Serial No. 06-598
KPS/LIC/GR: R3
Docket No. 50-305
License No. DPR-43

DOMINION ENERGY KEWAUNEE, INC.
KEWAUNEE POWER STATION
LICENSE AMENDMENT REQUEST - 217
REVISION TO REACTOR TRIP PERMISSIVE SETPOINTS

**LICENSE AMENDMENT REQUEST - 217
REVISION TO REACTOR TRIP PERMISSIVE SETPOINTS**

Figure 1
Kewaunee Power Station
Permissives

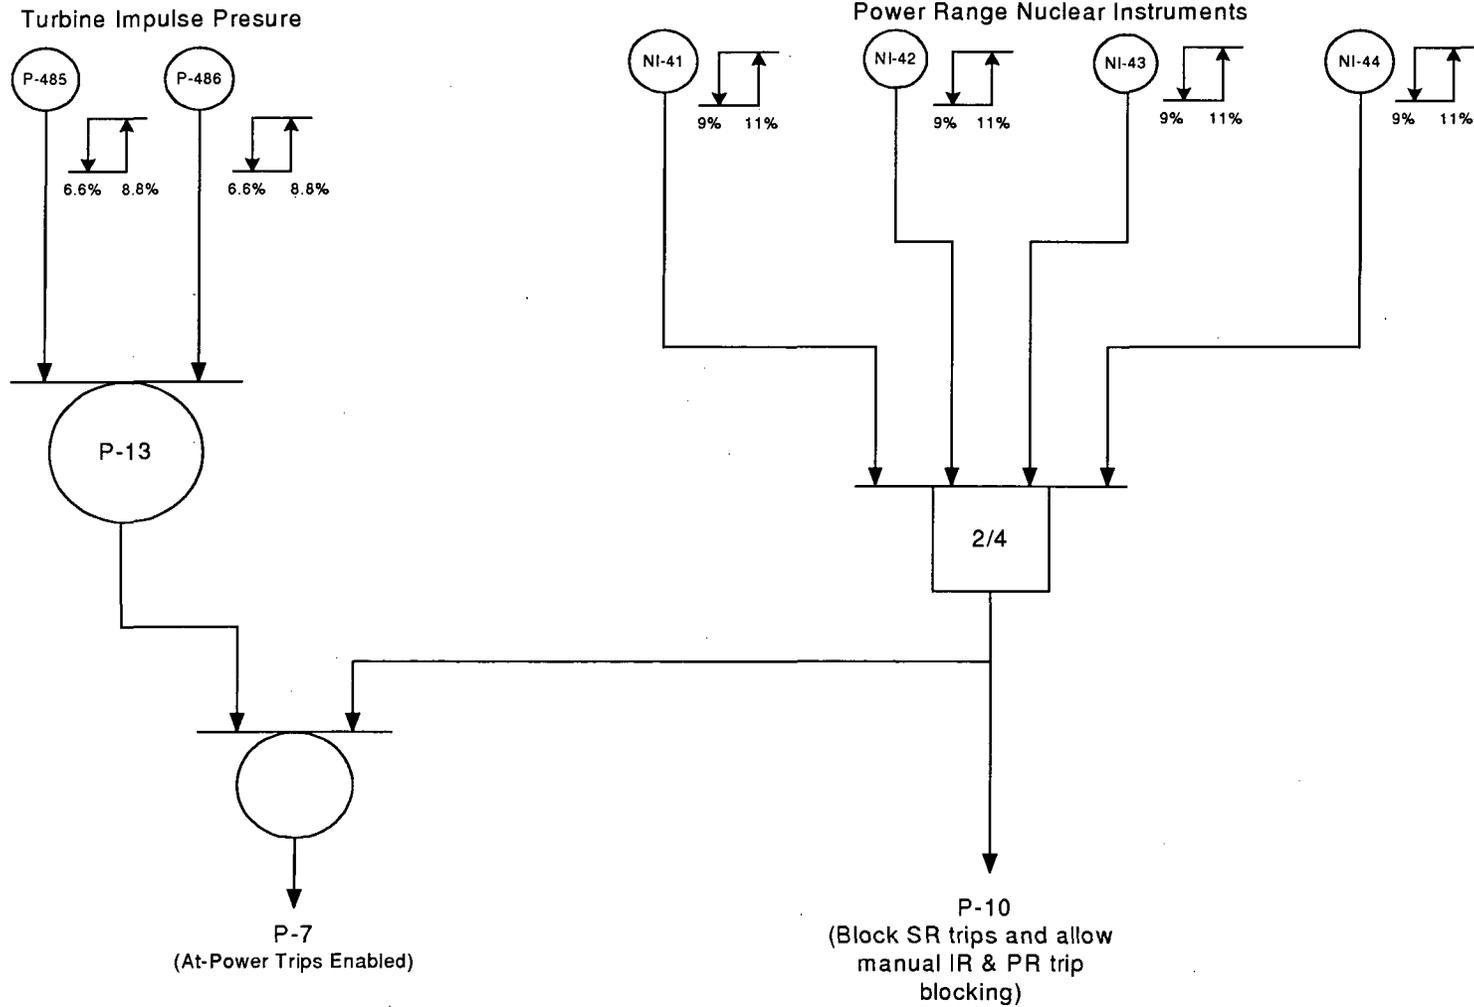
A logic drawing for permissives P-10 and P-7 is shown in Figure 1. Permissive P-10 and P-7 use the same logic relays but operate through different logic matrices and permissive relays. The difference between the P-10 and P-7 circuits is that the permissive relays for permissive P-10 de-energize to allow blocking the intermediate range and certain power range reactor trips while the P-7 permissive relays de-energize to enable the at-power reactor trips.

Using the setpoints listed in Figure 1, when two-of-four Power Range NI channels are greater than 11% power, a signal is sent to the P-10 and the P-7 permissives. This signal allows manual blocking of the IR NI channels High Flux reactor trip, manual blocking of the PR High Flux Low Setpoint reactor trip, and automatically enables the at-power trips. When two-of-four energized logic is not true (i.e., at least three-of-four NI channels less than 9% power) the signal is removed from P-10 and P-7, and unblocks the associated PR and IR channels reactor trips and automatically blocks the at-power trips, provided turbine impulse pressure is less than 6.6% power.

The four NI channels provide an input to the P-10 relay. As reactor power is increased to above 11%, the P-10 relay provides an output (when two of the four NI channels exceed the relay setpoint) to permit manual blocking of the IR High Flux and PR High Flux Low Setpoint reactor trips and an input to the P-7 relay, which enables the trips listed in TS 2.3.a.6.A. Note that the P-7 relay may already be activated if a turbine impulse pressure switch exceeds its setpoint before the NI channel bistables exceed their setpoint. Therefore, before exceeding 12.2% rated power, the at-power reactor trips are unblocked and manual blocking of the IR High Flux and PR High Flux Low Setpoint reactor trips is permitted.

On decreasing reactor power, when three-of-four P-10 relays reset (less than 9.0% rated power) the P-10 permissive is no longer satisfied and the IR High Flux and PR High Flux Low Setpoint reactor trips are unblocked while the trips blocked by P-7 are automatically blocked, provided the turbine impulse pressure circuit indicates impulse pressure is less than its reset point.

Because both the P-7 and P-10 circuits use the same logic relays, the settings for permissive P-10 and P-7 cannot be identical since one permissive operates from the set function of the logic relays while the other operates from the reset function of the logic relays. Based on this inherent difference in relay operation, a setpoint band is needed to allow proper setting of the permissives while maintaining the nominal 10% reactor power setpoint used since initial plant start up.

DEK has performed a calculation to determine the P-10 and P-7 setpoint uncertainties. The proposed change to TS Table 3.5-2 permissives P-10 and P-7 equates to a high setting limit of 12.2% with a low setting limit of 7.8%. The calculation results show that the loop drift of the NI instrumentation is +/- 0.67%. After adjusting the setting limits for instrumentation loop drift and using 2% for the relay set to reset difference (the actual plant setting for the relays to close is at 11% and open at 9%) a margin of 0.53% remains between the setting limits and the actual plant setpoints. Figure 2 shows the proposed setpoints, uncertainties, and margins for the P-10 and P-7 relays.

Figure 2
Setpoint Uncertainties

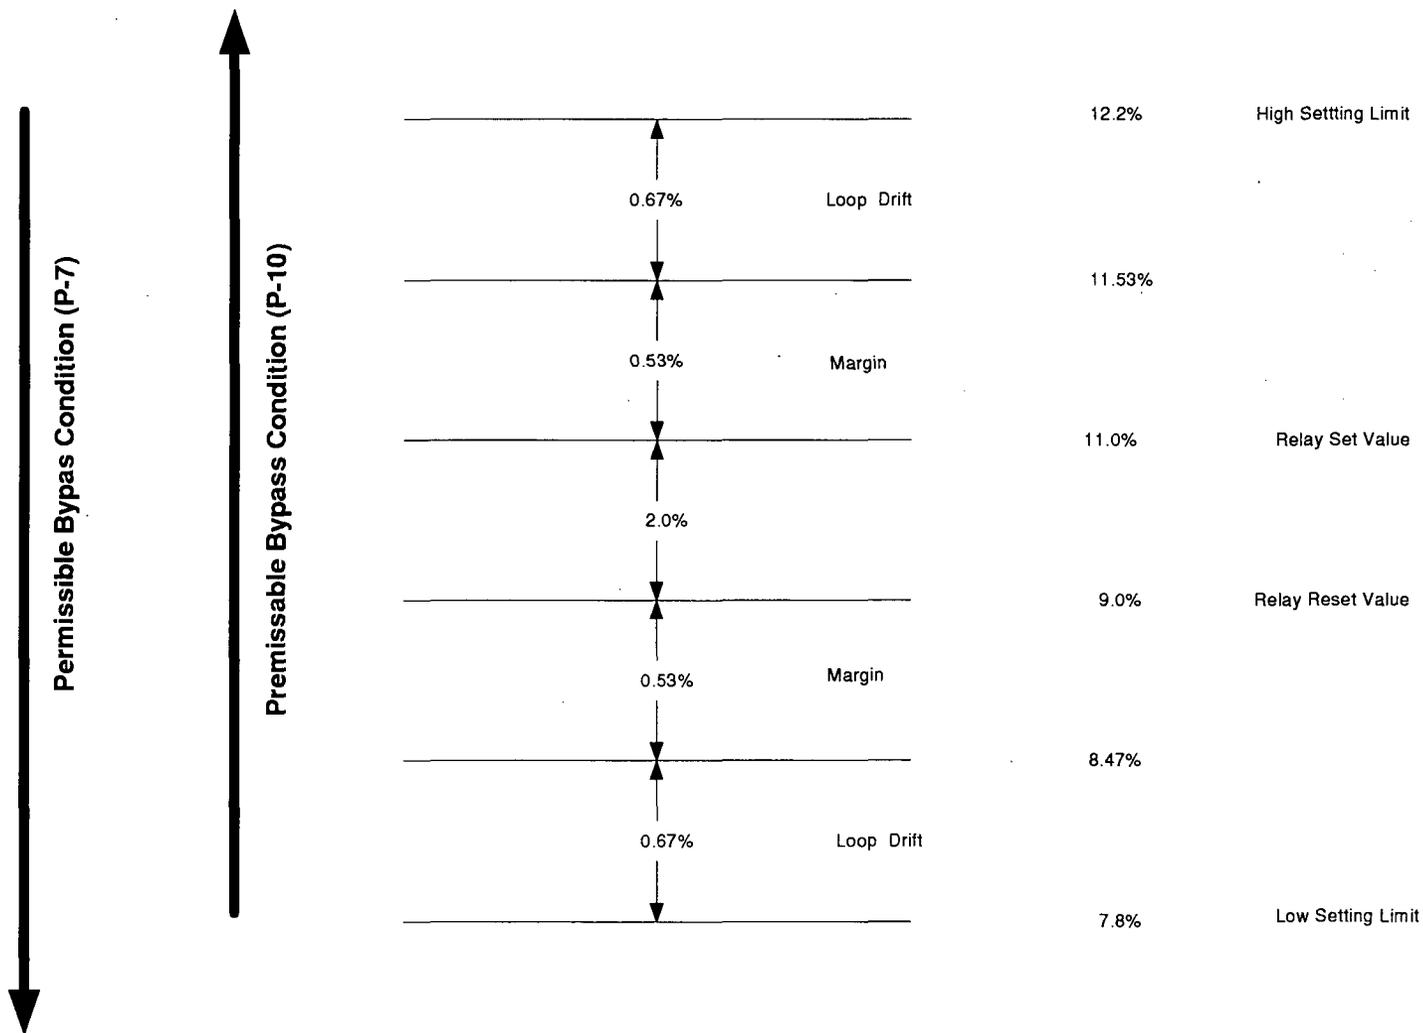
Additionally, the above STS excerpt contains a “Reviewer’s Note” stating that some units TS may only contain an allowable value. This proposed change is similar in nature to that statement. The similarity is that Kewaunee CTS currently contain what could be considered the “Nominal Trip Setpoint” (10% reactor power). This proposed change would allow maintaining a nominal trip setpoint of approximately 10% by changing the technical specifications to model the allowable value by adding a band for the setting limit. The permissive P-10 nominal trip setpoint would be bounded by the lower limit of the permissive P-10 value contained in the TS Table 3.5-2 NOTE permissive table for Kewaunee (7.8% reactor power) and bounded by the upper limit of the P-7 power range nuclear instrument value (12.2% reactor power) (refer to Figure 2).
